Subject: Submittal of Revised Final Additional DNAPL Recovery Well Installation
and Testing Work Plan
Detrex Source Control Area – Fields Brook Superfund Site
Detrex Corporation, Ashtabula, Ohio
Docket No. V-W-98-C-450

ADDITIONAL DNAPL RECOVERY WELL INSTALLATION AND TESTING WORK PLAN

**DETREX RD/RA SOURCE CONTROL AREA
DETREX FACILITY
ASHTABULA, OHIO
DOCKET NO. V-W-98-C-450**

**TECHNICAL REVIEW COMMENTS ON
"ADDITIONAL DNAPL RECOVERY WELL INSTALLATION
AND TESTING WORK PLAN"
URS Corporation, February 2012**

DRAWN BY: AMH	CHECKED BY: MLS	PROJECT No: 13814865	DATE: 8/20/12	FIGURE No: 2-3
------------------	--------------------	-------------------------	------------------	-------------------

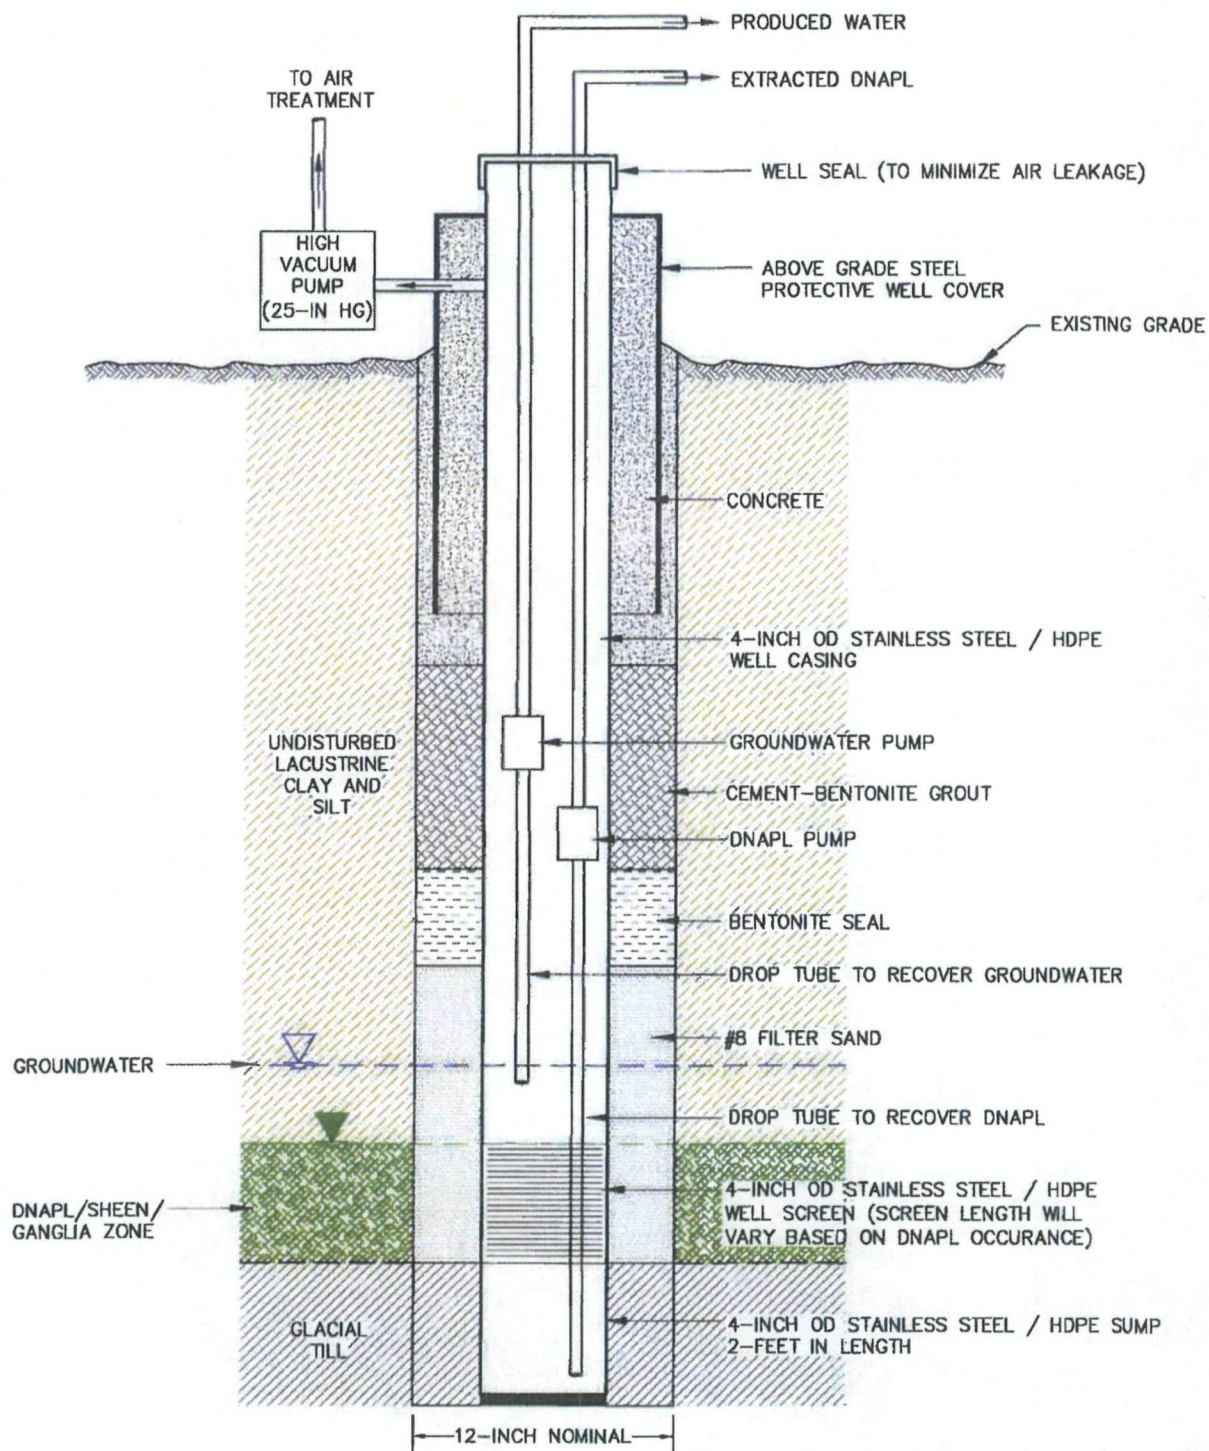
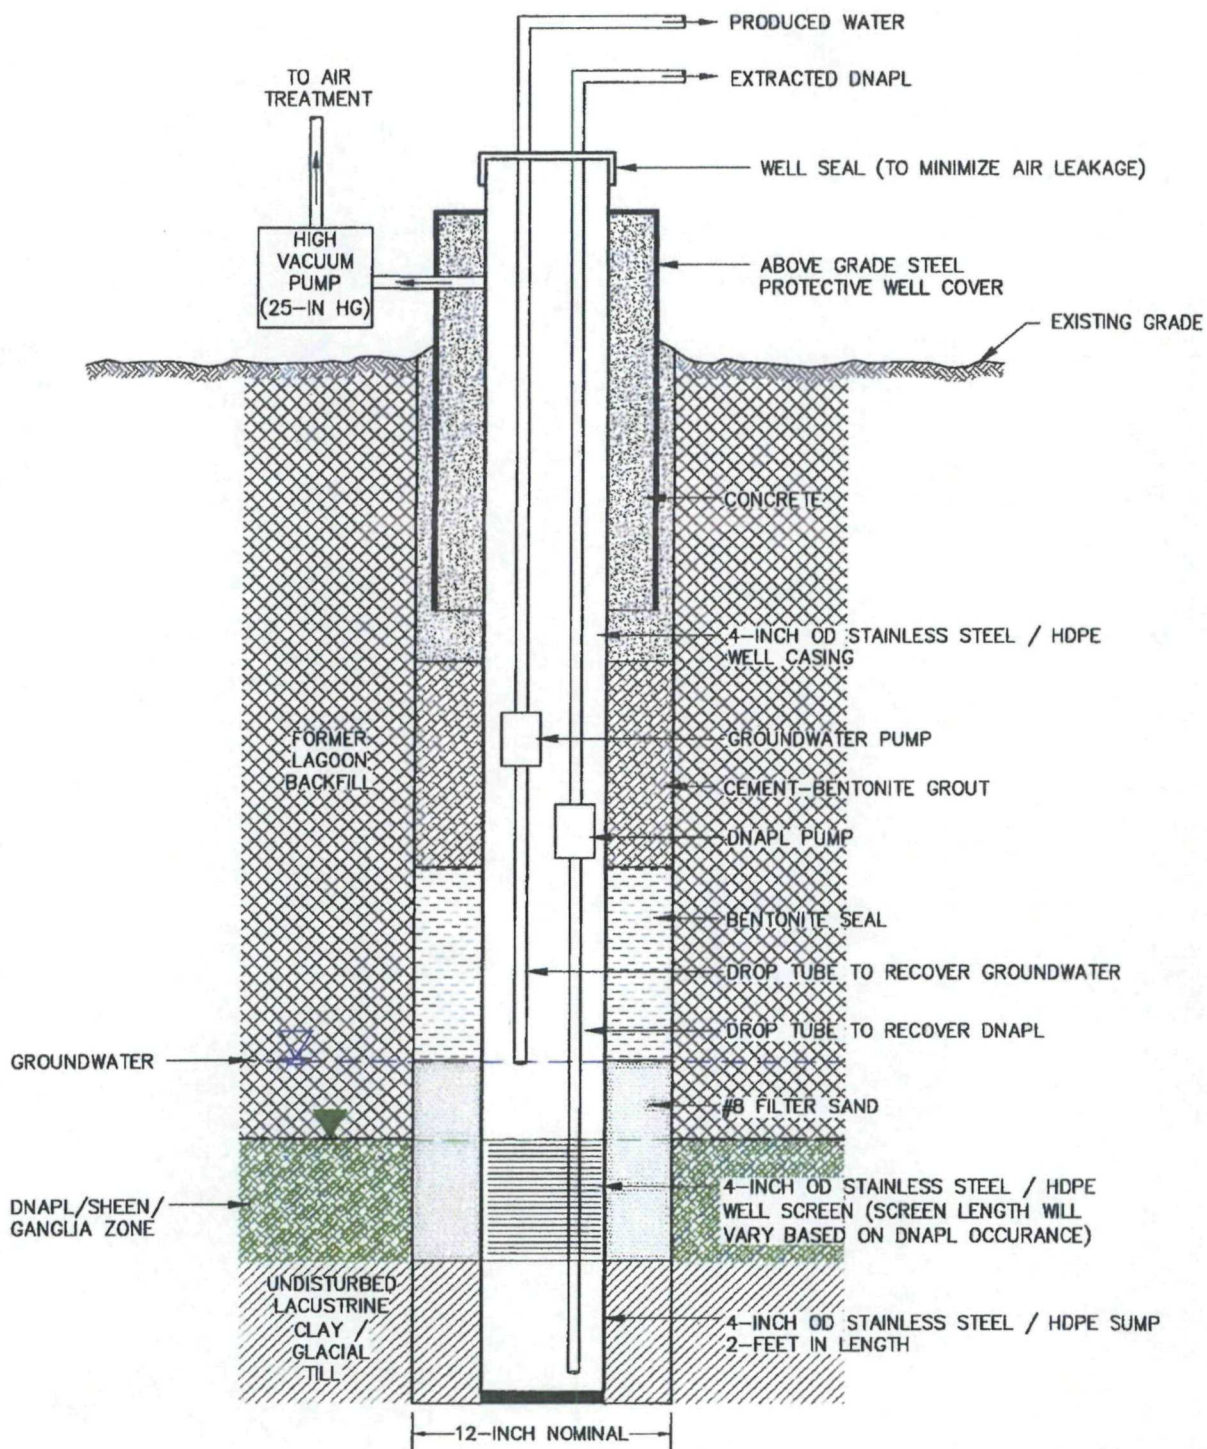
11. Section 2.3.5, Page 2-8; and Figures 2-4 and 2-5: The text states that "new DNAPL recovery wells will be installed in 12-inch diameter boreholes"; however, Figures 2-4 and 2-5 show the boreholes as having a 10-inch-diameter. The text and figures should be revised as needed to resolve this discrepancy.

Specific Comment #11 - Section 2.3.5, Page 2-8; and Figures 2-4 and 2-5: The text states that "new DNAPL recovery wells will be installed in 12-inch diameter boreholes"; however, Figures 2-4 and 2-5 show the boreholes as having a 10-inch-diameter. The text and figures should be revised as needed to resolve this discrepancy.

Detrex agrees. Figures 2-3, 2-4, and 2-5 have been revised to reference the use of 12 inch boreholes for DNAPL recovery wells.

DRAWN BY: AMH	CHECKED BY: MLS	PROJECT No: 13814865	DATE: 8/16/12	FIGURE No: 2-6
------------------	--------------------	-------------------------	------------------	-------------------

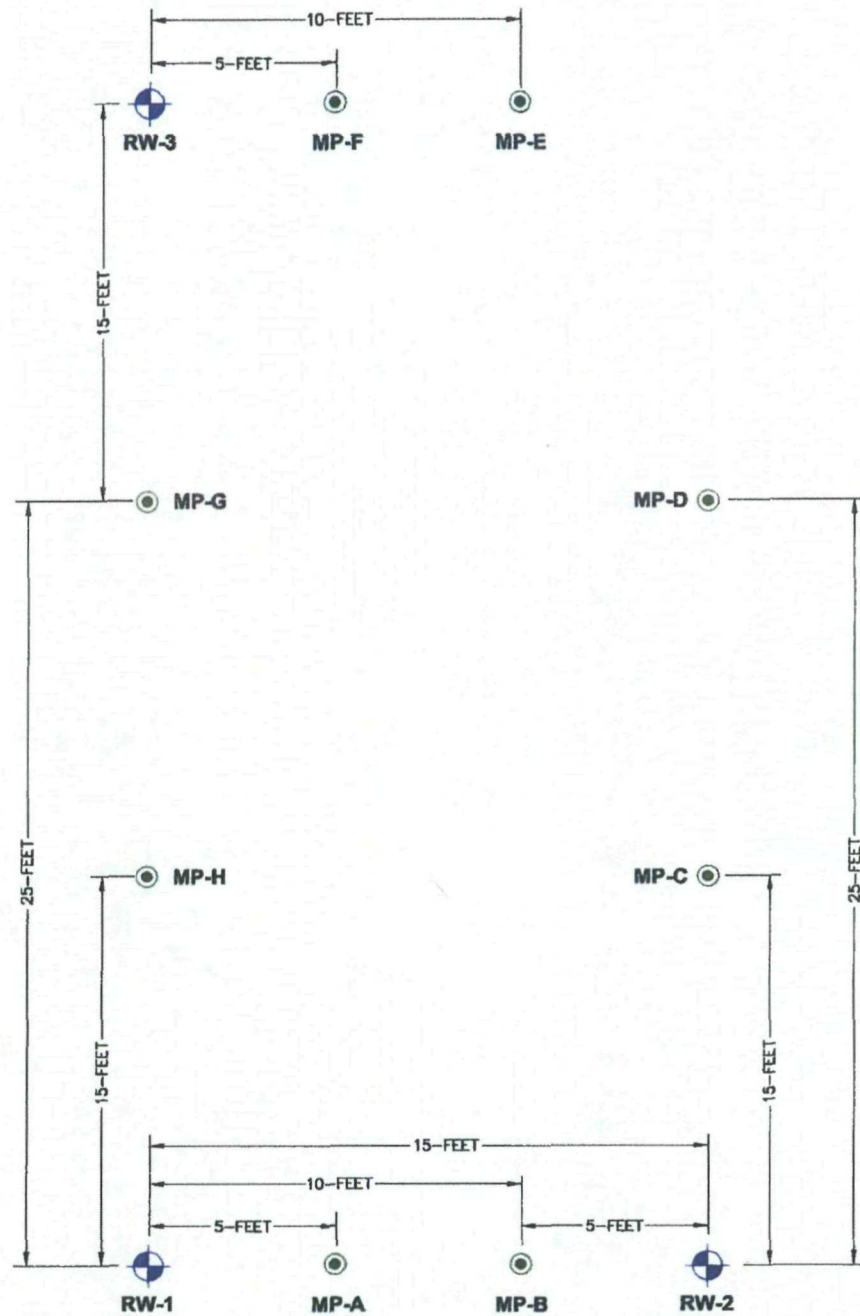
8. **Section 2.3.5.2, Figure 2-6:** For the testing area within the footprint of the former lagoon, the figure should include an additional probe location or two outside the former lagoon footprint to provide information regarding the effectiveness of recovery wells inside the lagoon on areas outside the lagoon. This information would be useful for any full-scale design.
